Fix for the FrankenBoard Voltage Monitor Circuit

Till Straumann <straumanATslac.stanford.edu>, 2004

March 8, 2004

Figure 2: “Blue wire” correction to the FrankenBoard needed for correctly sensing the ground fault voltage. Without the fix, the diode protection network present on the FrankenBoard clamps the ground sense voltage to $\approx \pm 0.7V$.

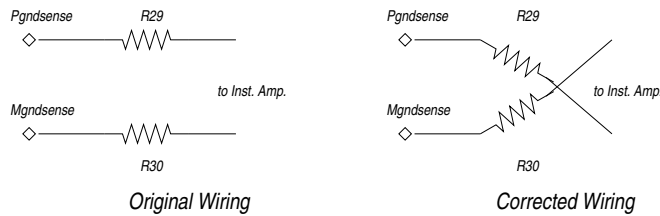
As of the time of this writing, the ground sense front-end circuit of the *FrankenBoard* exhibits a design flaw, preventing it from sensing any ground fault voltage (input terminals must be interchanged, e.g., by

unsoldering R29 and R30 and making the necessary crossover connections). A blue wire modification of the FrankenBoard is required as indicated on fig. 2.
